Access Compliance Report

Public Rights-of-Way

(Curb Ramps)

Intersection ID: N/A	Main Street: PERTH_MOOR_RD	Cross Street: HAMILTON_BRIDGE_RD	Location: NE
ADA ID: DC33F5838B07	Ramp Type: Perp	Initial Pass/Fail: Fail	Overall Compliance: No
		Severity Score: 25

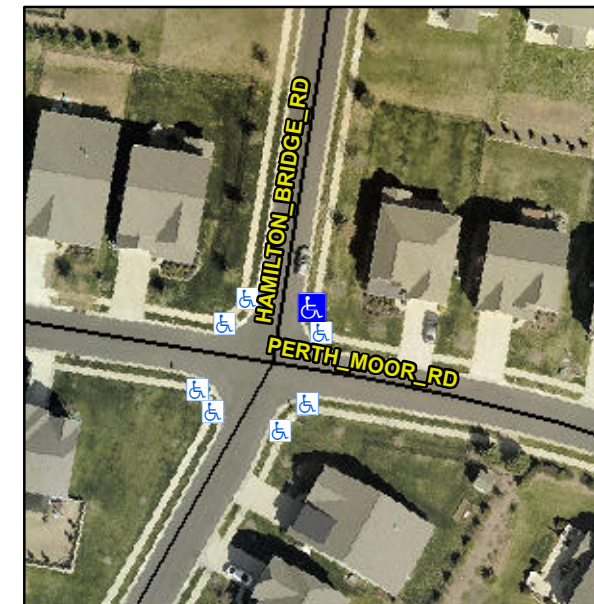
R304.2.2, R304.5.3

Compliance	Description	Data	Compliance	Description	Data
N/A	Ramp Length (in)	48.0	No	Ramp Slope (%)	11.5
Yes	Ramp Width (in)	48.0	No	Ramp XSlope (%)	6.8
N/A	Flare Type LT	N/A	N/A	Flare Type RT	N/A
N/A	Flare Slope LT (%)	N/A	N/A	Flare Slope RT (%)	N/A
N/A	Flare Traversable LT?	N/A	N/A	Flare Traversable RT?	N/A
N/A	Landing Length (in)	N/A	N/A	DWS Provided?	N/A
N/A	Landing Width (in)	N/A	N/A	DWS Contrast?	N/A
N/A	Landing Slope (%)	N/A	N/A	DWS Length (in)	N/A
N/A	Landing X Slope (%)	N/A	N/A	DWS Full Width?	N/A
N/A	Landing Curb? (Y/N)	N/A	N/A	DWS Offset (in)	N/A
N/A	Shared Landing?	N/A			
N/A	Gutter Ponding?	N/A	N/A	Gutter Slope (%)	N/A
N/A	Gutter Lip Ht (in)	1.0	N/A	Gutter X Slope (%)	N/A
N/A	Painted X Walk1?	No	N/A	Painted X Walk2?	N/A
	X Walk 1 Direction	To NW		X Walk 2 Direction	N/A
N/A	X Walk 1 Width (in)	N/A	N/A	X Walk 2 Width (in)	N/A
	X Walk 1 Slope (%)	1.9		X Walk 2 Slope (%)	N/A
	X Walk 1 X Slope (%)	5.4		X Walk 2 X Slope (%)	N/A

Remove & Replace Entire Ramp.
